V2500-D5 SERIES PROPULSION SYSTEMS SERVICE BULLETIN

This document transmits Revision 3 to Service Bulletin EV2500-73-0105 and Revision 1 to the Supplement

V2500-ENG-73-0105

ENGINE FUEL AND CONTROL – FUEL SYSTEM AIR TUBES – INTRODUCTION OF ADDITIONAL MOISTURE
TRAP ON THE PB SENSE LINE AIR TUBE ASSEMBLY

Part view - RH of engine - Before alteration
Figure 1

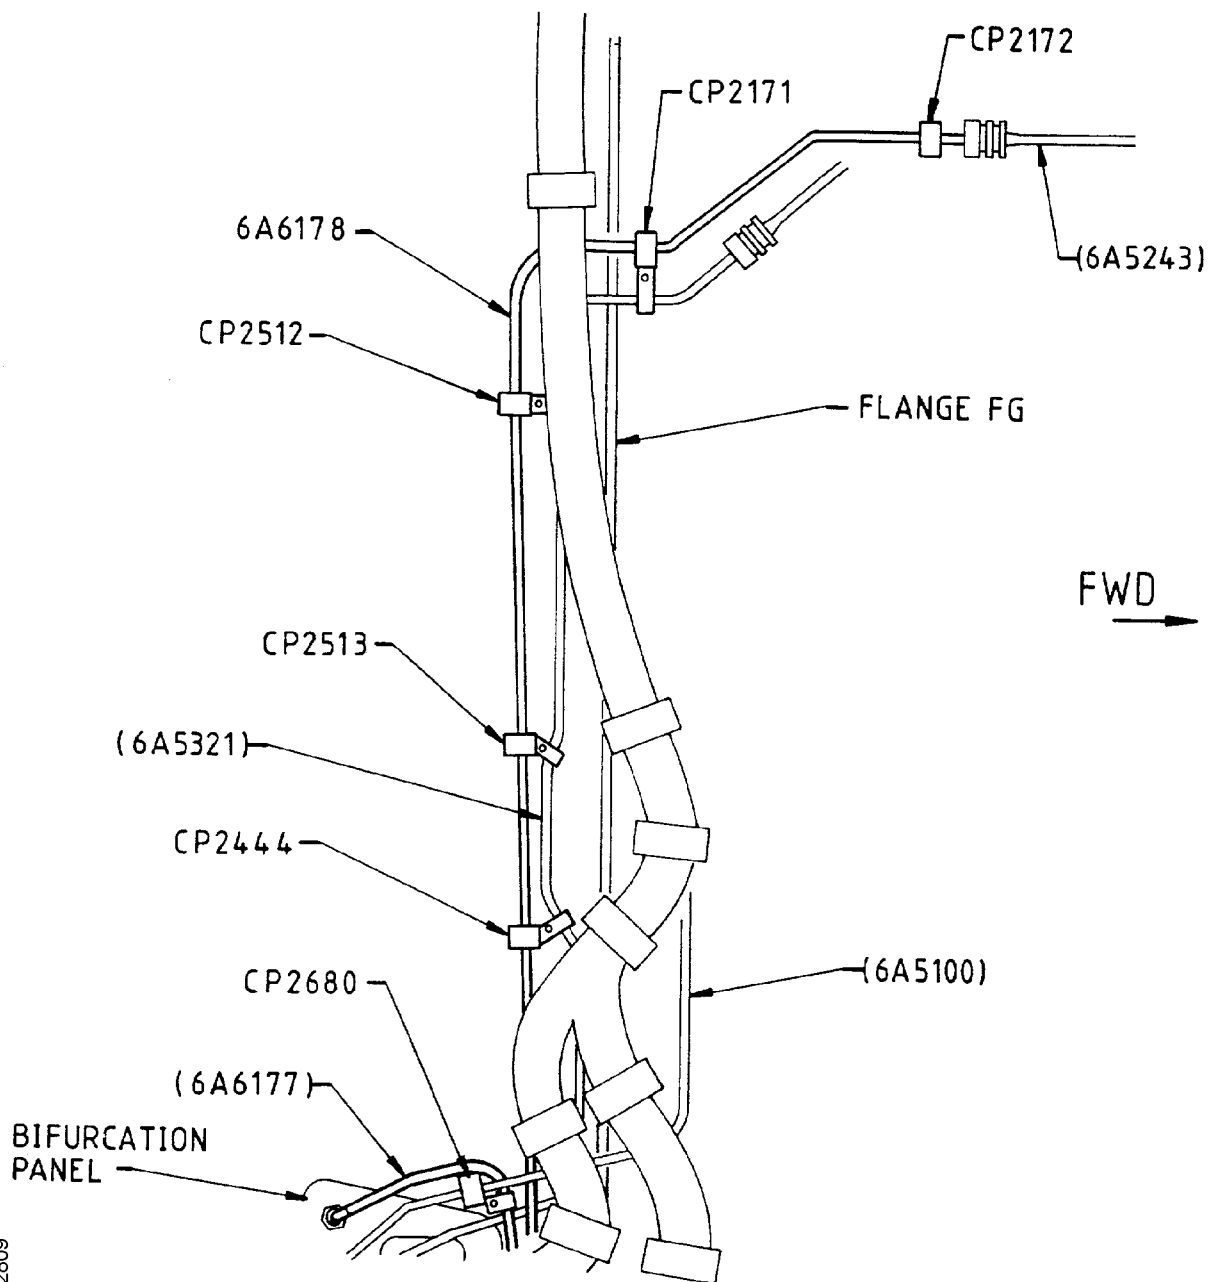
- (1) Identify the Pb pressure air tubes 6A5322 and 6A5243 of the burner. These are between the RH bifurcation panel and the support raft. (Refer to Figure 1).

- (2) Disassemble the clip points CP2444, CP2512 and CP2513. Keep the nuts and bolts. (Refer to Figure 1).
- (3) Remove the air tube 6A5322 (Refer to Figure 1).

Part view - RH of engine - After alteration
Figure 2

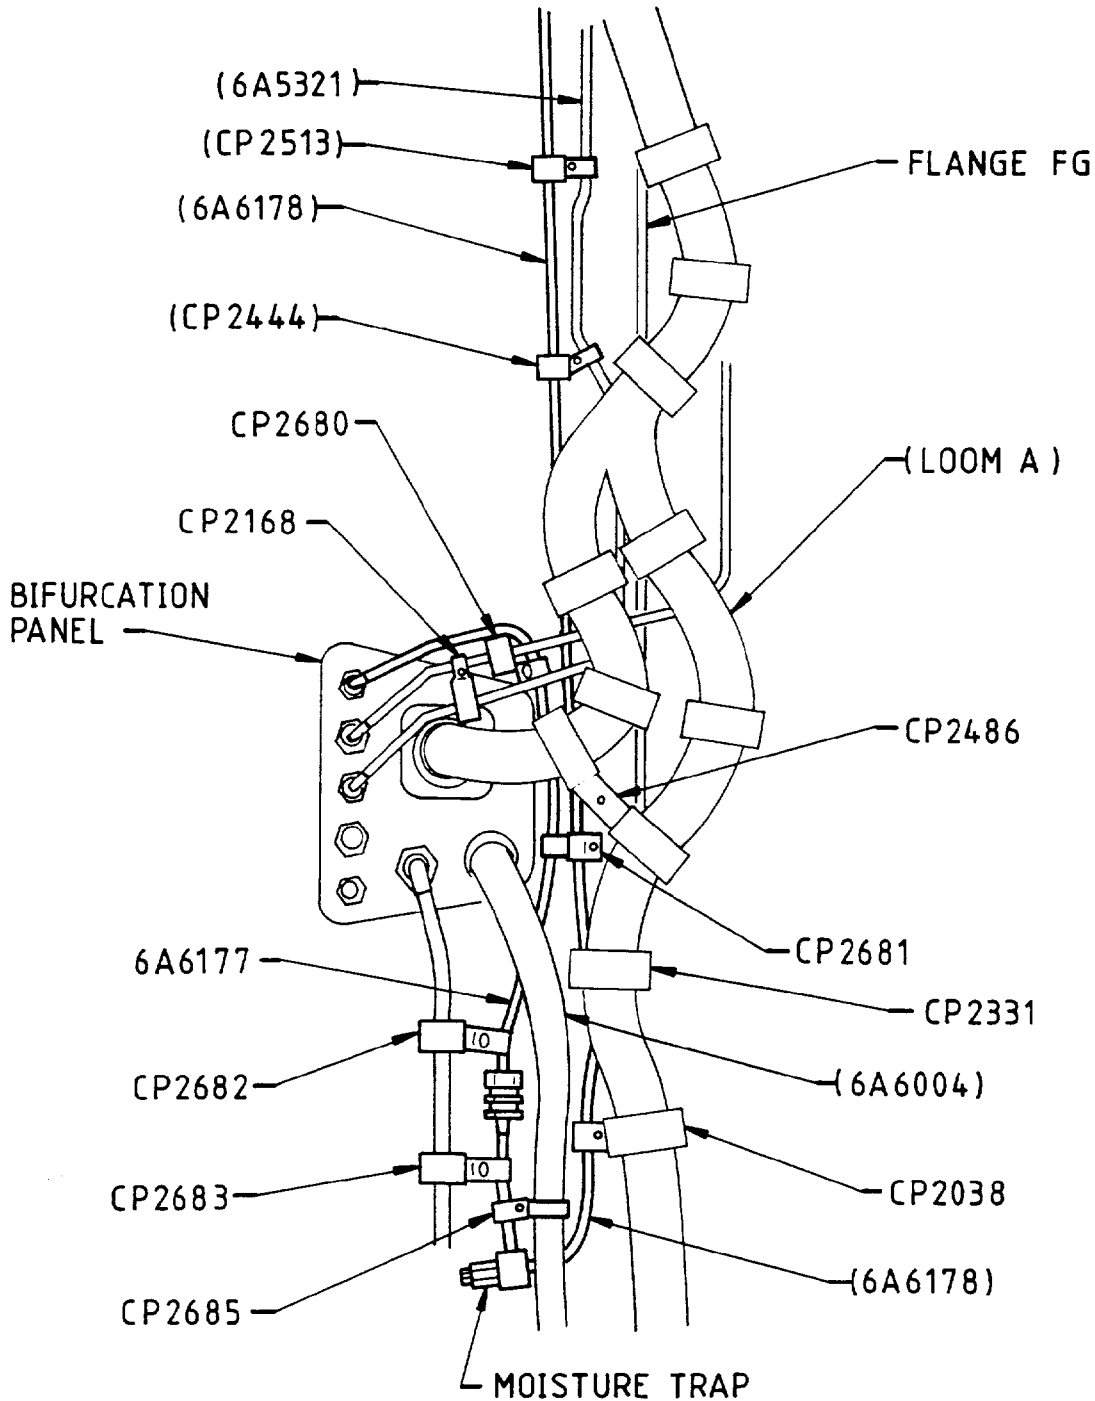
- (ii) Turn the tube and put the top end behind Loom-A and over the tubes.
 - (b) Loosely connect tube 6A6178 to air tube 6A5243 (Refer to Figures 1 and 2).

- (g) Install the five clips removed at C.(3)(d) to tube 6A6178.
 - (h) With the nuts and bolts removed at step C.(2), assemble clip points CP2444, CP2512 and CP2513 (Refer to Figure 2).

- (i) With the bolts and spacers removed at step C.(3)(a), assemble clip points CP2171 and CP2172 (Refer to Figure 2).
- (j) Install CP2038 (Refer to Figures 3 and 4).

Part view - RH Bifurcation - After alteration
Figure 3

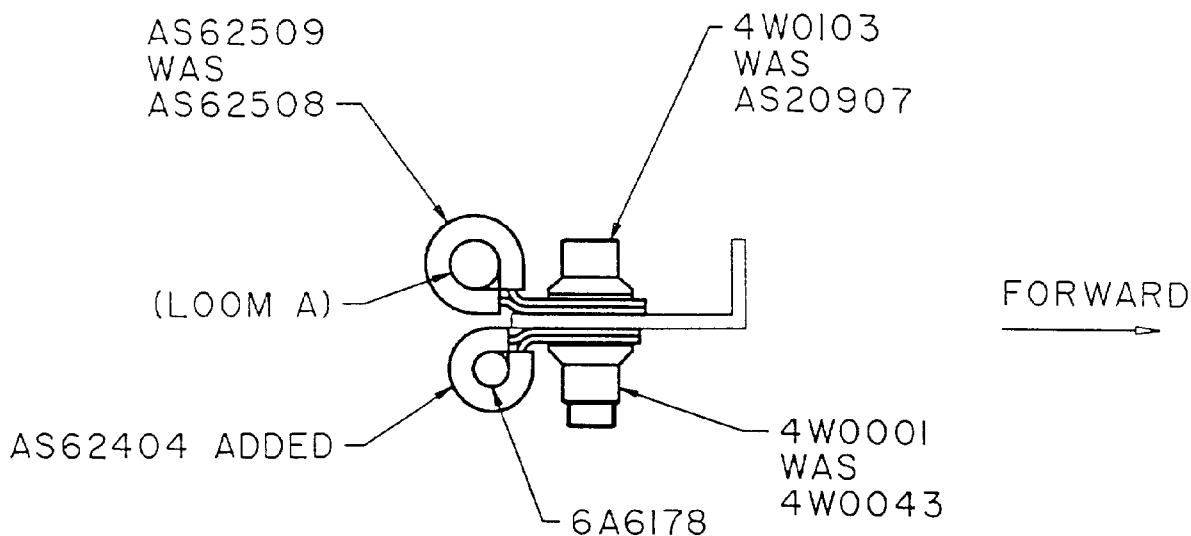
- (i) Torque load the union to between 159 and 177 lbfin. (18 to 20 Nm).
 - (ii) Safety the union with OMat 02-126 lockwire (Refer to Figure 3).
 - (e) At the connection with 6A5243, tighten the union of 6A6178

- (f) At the connection of 6A6177 with 6A6178, tighten the union of 6A6177
 - (i) Torque load the union to between 159 and 177 lbfin. (18 to 20 Nm).
 - (ii) Safety the union with OMat 02-126 lockwire (Refer to Figure 3).

Clip points CP2038 and CP2331 - Before and after alteration
Figure 4

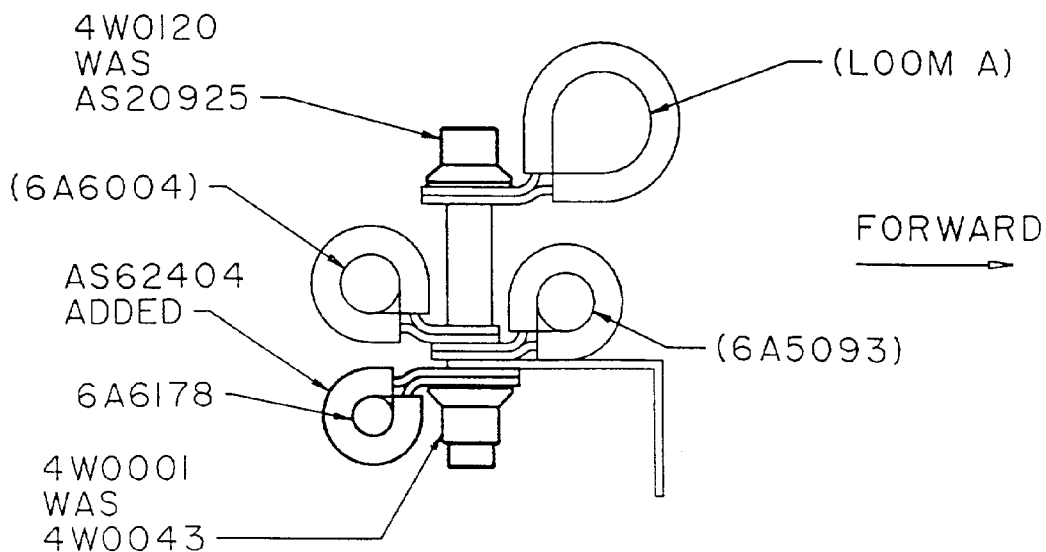
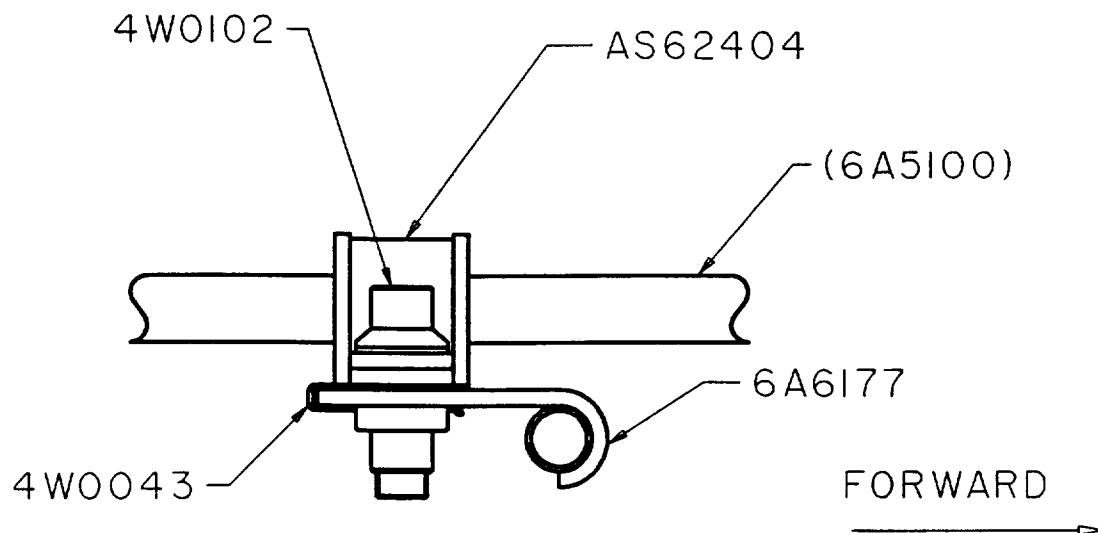
- (c) Remove tube 6A5322.
 - (d) Remove and keep the five clips from the air tube 6A5322.
- (4) Disassemble clip point CP2038. Keep the spacer but discard the bolt and clipnut (Refer to Figures 3 and 4).

- (5) Disassemble clip point CP2331. Discard the bolt and clipnut (Refer to Figures 3 and 4).
- (6) Disassemble clip point CP2168 and discard the bolt (Refer to Figures 3 and 9).

- (i) Install clip AS62406 to tube 6A6178.
 - (ii) With the spacer removed at step C.(4) and the new bolt 4W0120 and nut 4W0001, assemble CP2038.
 - (iii) Torque load the nut to between 36 and 45 lbfin. (4 to 5 Nm).

- (k) Install CP2331 (Refer to Figures 3 and 4).
 - (i) Install clip AS62404 to tube 6A6178.
 - (ii) With the new bolt 4W0103 and nut 4W0001, assemble CP2331.

Clip points CP2680 and CP2681 - Additional
Figure 5

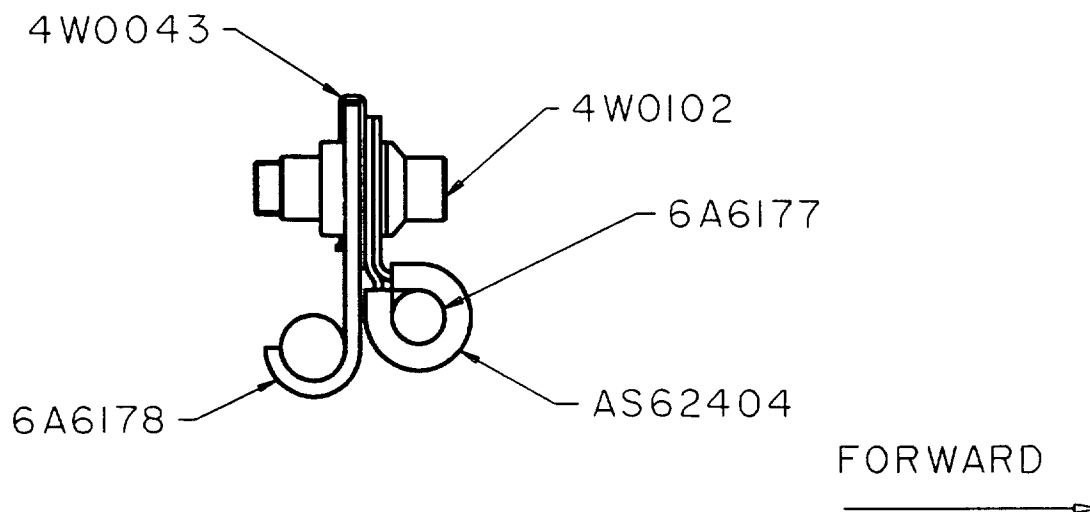
- (iii) Torque load the nut to between 36 and 45 lbfin. (4 to 5 Nm).
- (l) Install CP2681 (Refer to Figures 3 and 5).
 - (i) Install clip AS62404 to tube 6A6177.

- (ii) With the new bolt 4W0102 and nut 4W0043, assemble CP2681.
 - (iii) Torque load the nut to between 36 and 45 lbfin. (4 to 5 Nm).
- (2) Install the clip point CP2680 (Refer to Figures 2 and 5)

- (a) Install clip AS62404 on tube 6A5100.
 - (b) With the new bolt 4W0102 assemble the clip point.
- (3) Install the clip points CP2682 and CP2683 (Refer to Figures 3 and 6)

Clip points CP2682 and CP2683 - Additional
Figure 6

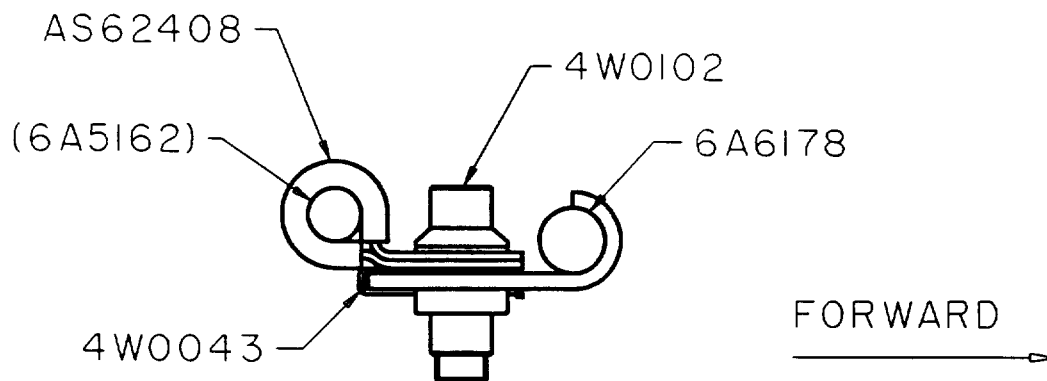
- (a) Install the two clips AS62408 on tube 6A5162.
 - (b) With the new bolts 4W0102 and nuts 4W0043 assemble the clip point.
- (4) Install the clip point CP2685 (Refer to Figures 3 and 7)

Clip point CP2685 - Additional
Figure 7

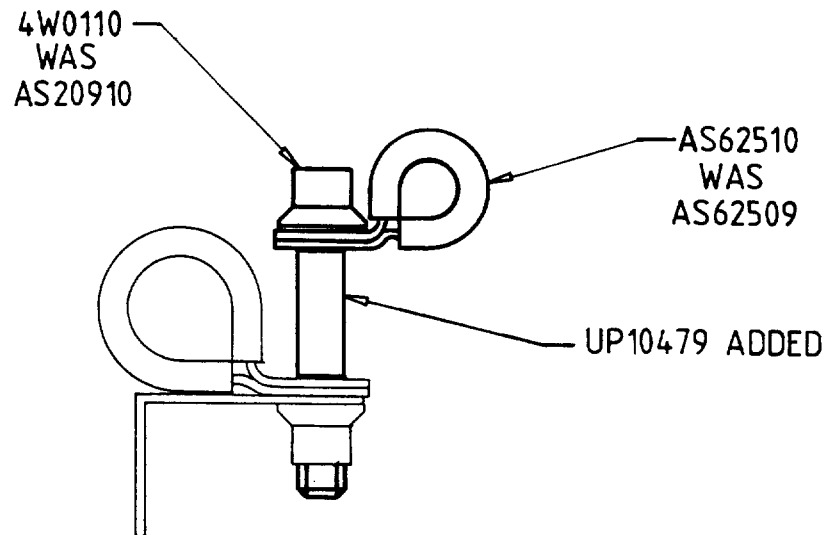
- (a) Install the clip AS62412 on the fuel tube 6A6004.
 - (b) With the new bolt 4W0109, spacer UP10479 and nut 4W0001 assemble the clip point.
- (5) With the new bolt 4W0102, assemble the clip point CP2168 (Refer to Figures 3 and 9).

Clip point CP2486 - Before and after alteration
Figure 8

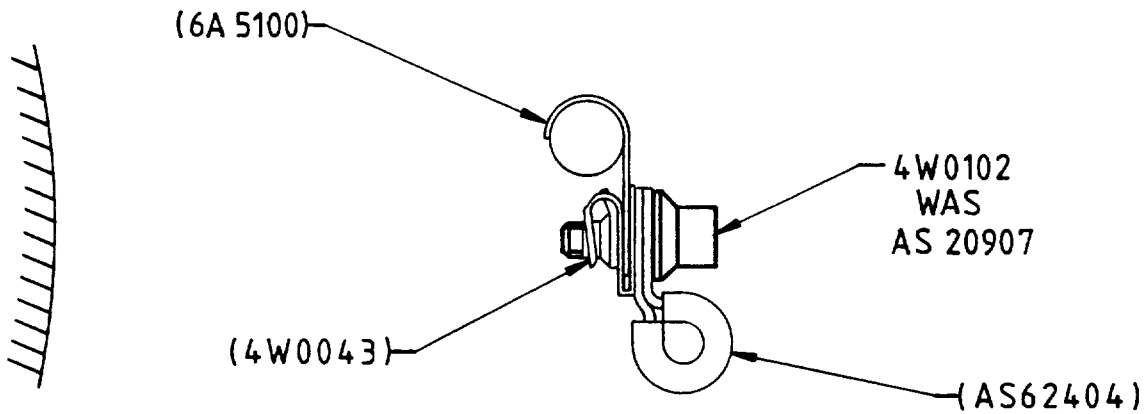
- (7) Disassemble clip point CP2486 and discard the bolt (Refer to Figures 3 and 8).

- (6) With the new clip AS26510, bolt 4W0110 and spacer UP10479, assemble the clip point CP2486.
- (7) Torque load the bolts at clip points CP2168, CP2486, CP2680, CP2682, CP2683 and CP2685 to between 36 and 45 lbfin. (4 to 5 Nm).
